HIGHLAND CITY
HIGHLAND CITY DEVELOPMENT
ADMINISTRATION BOARD AGENDA
Thursday, August 28, 2025

DATE: August 28, 2025
TO: Development Administration Board
FROM: Rob Patterson, City Attorney / Planning & Zoning Administrator
SUBJECT: **Final Plat Approval:** Sloan Estates
TYPE: **LAND USE (ADMINISTRATIVE)**

DATE: August 28, 2025
TO: Development Administration Board
FROM: Rob Patterson, City Attorney / Planning & Zoning Administrator
SUBJECT: **Final Plat Approval:** Inverness - Highland Blvd
TYPE: **LAND USE (ADMINISTRATIVE)**

HIGHLAND BLVD
 HIGHLAND, UTAH
 DEMOLITION PLAN 1

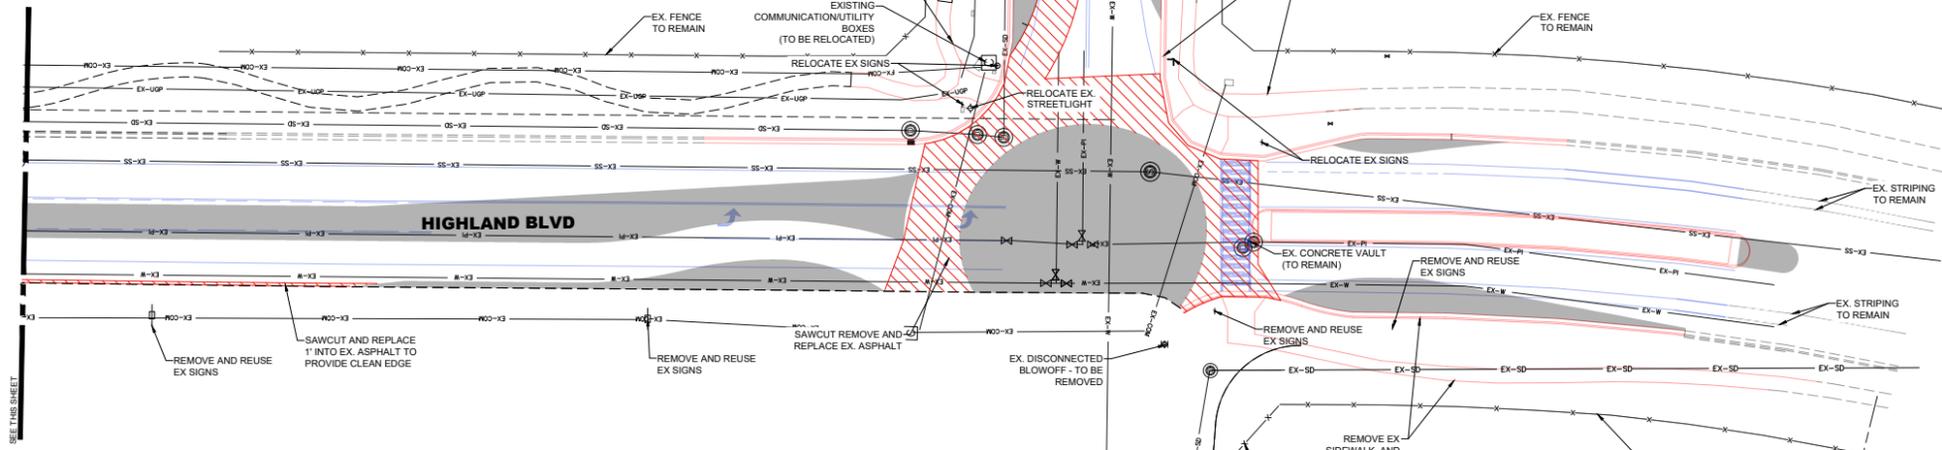
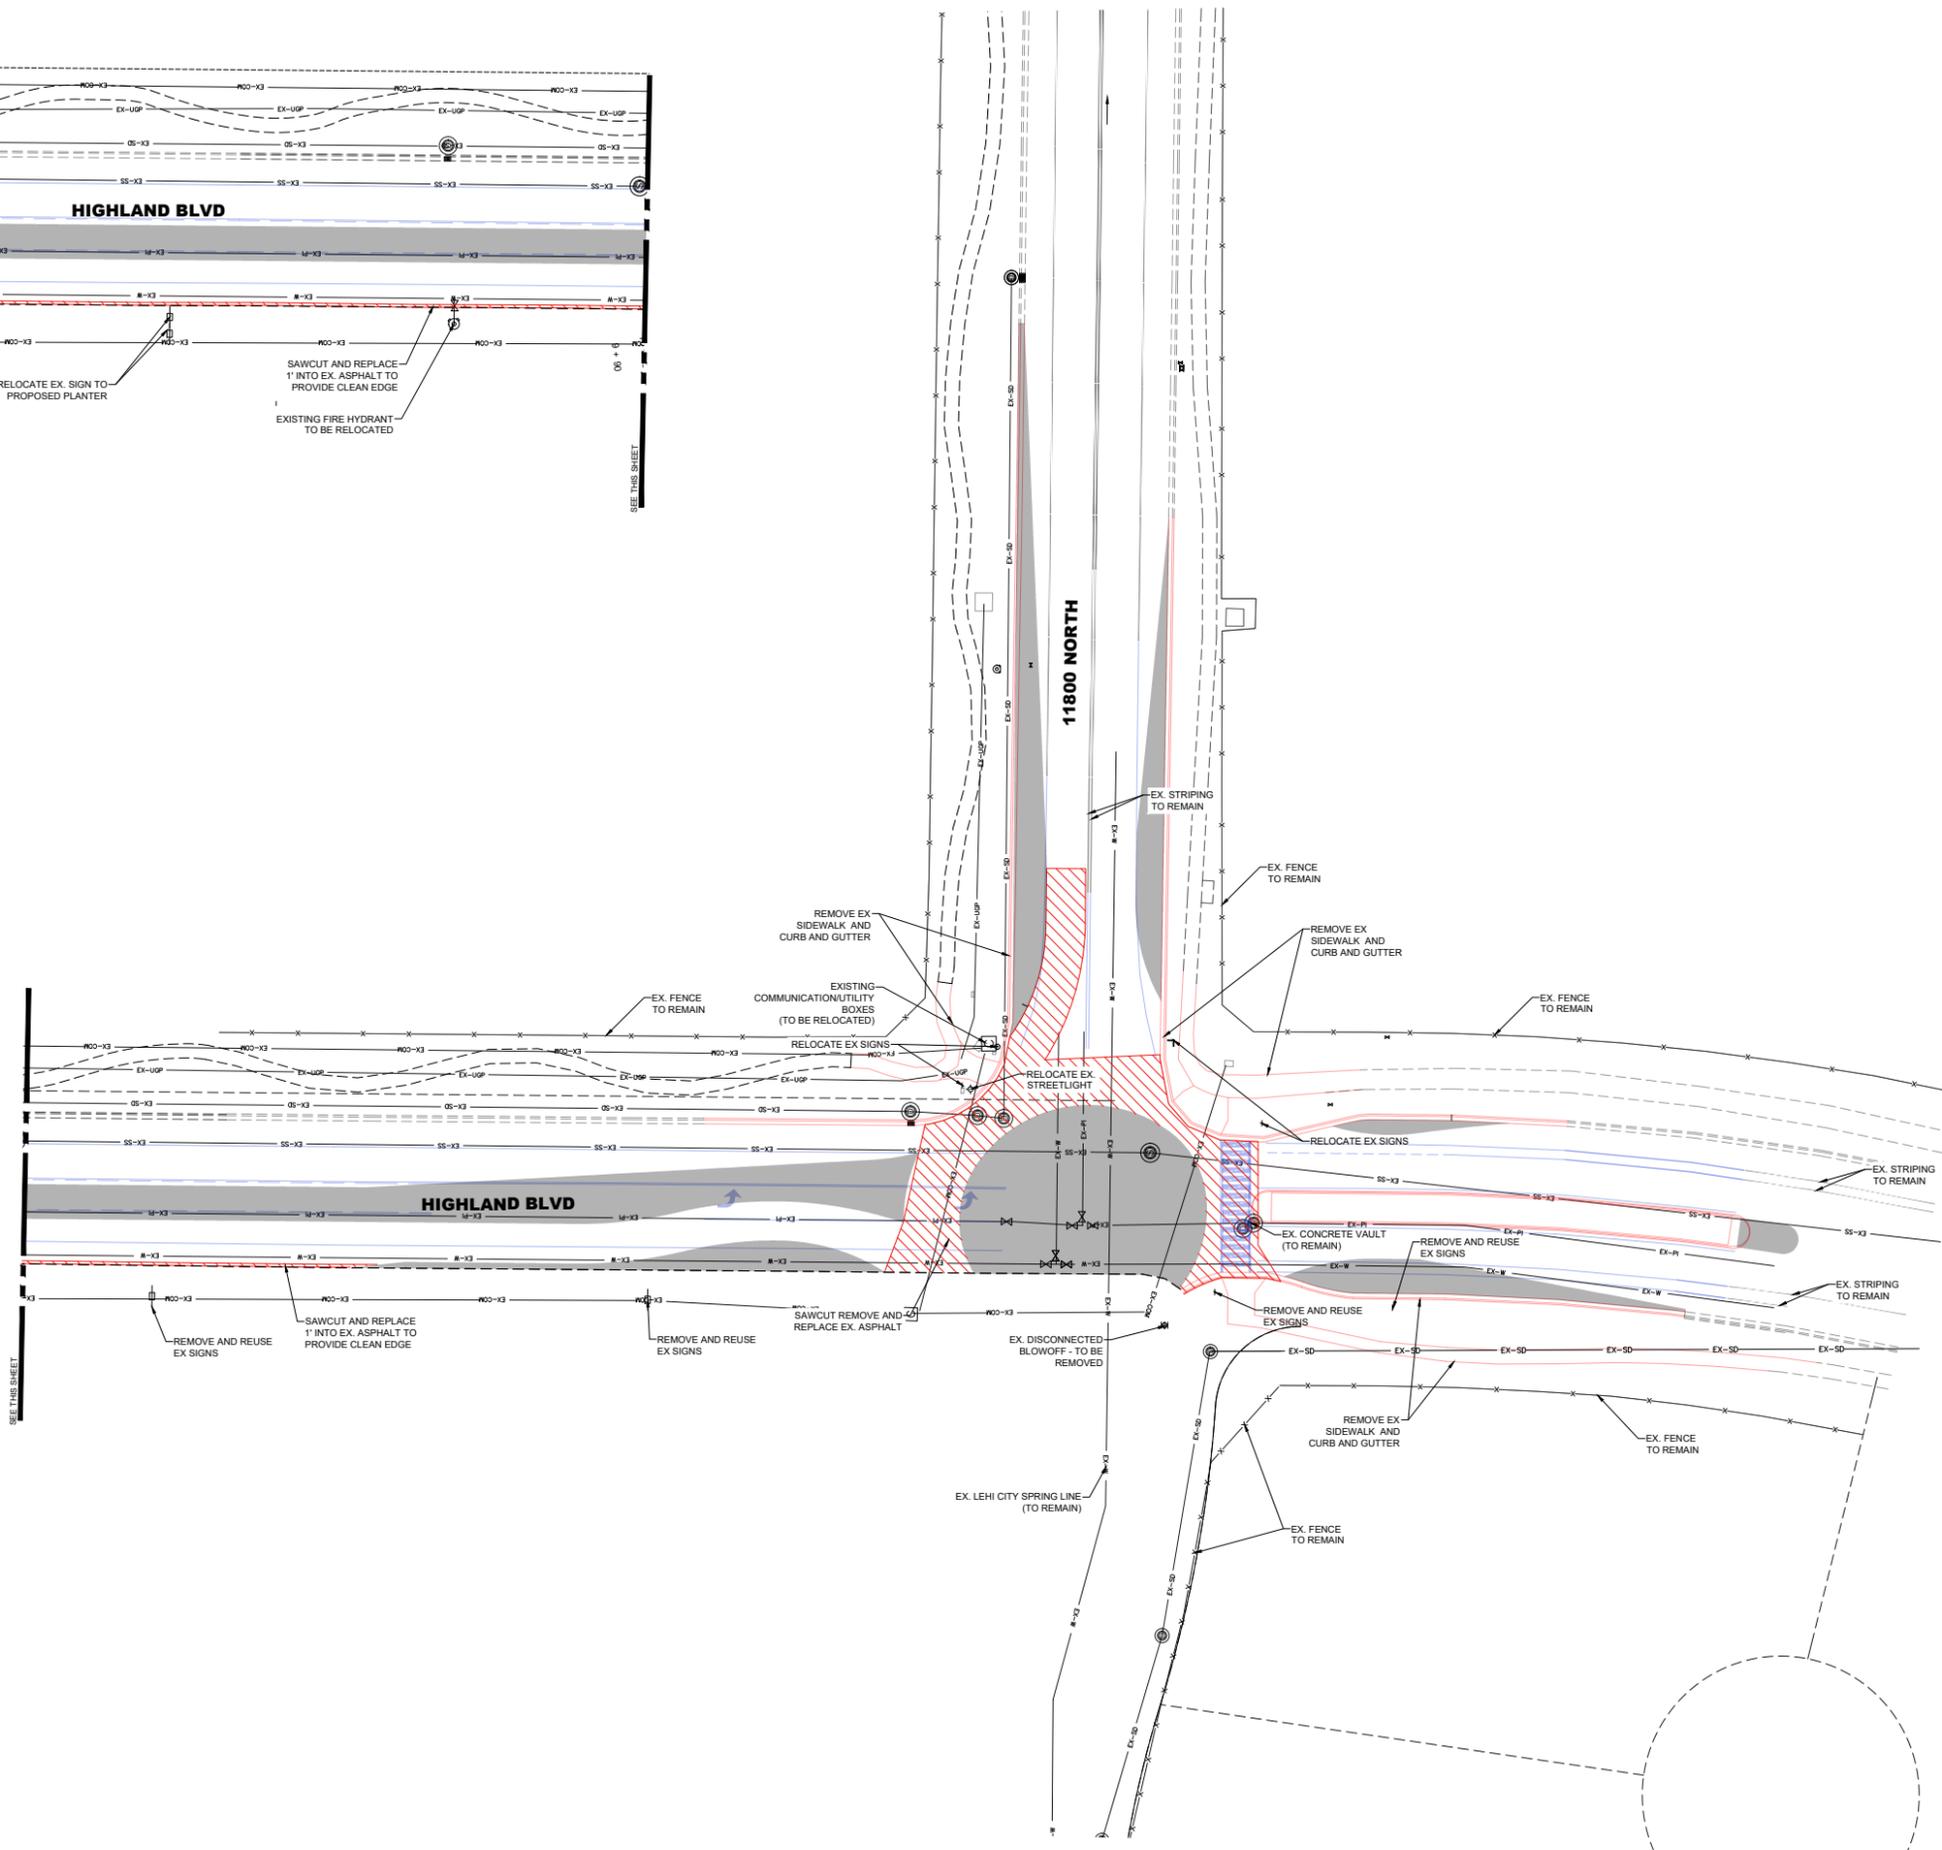
1. New and relocated fire hydrants along Highland Blvd, need bollards installed for added protection.
2. Show tapping location for PI service for landscaping of roundabout

P DRIP CONTROL ZONE KIT DETAIL
NOT TO SCALE

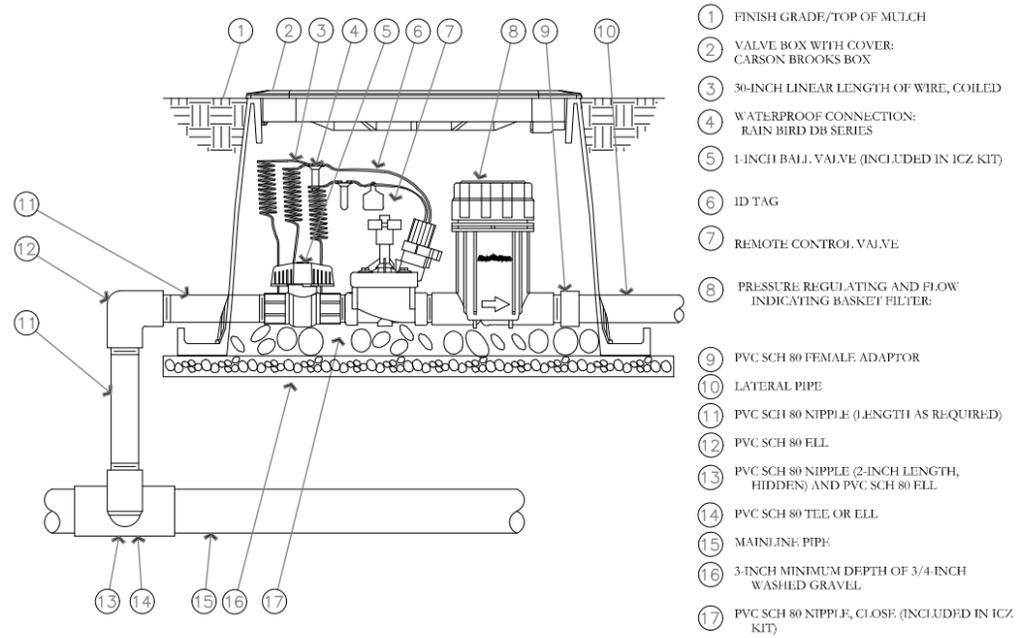
1. Detail P note 9 Action union, no male adaptor
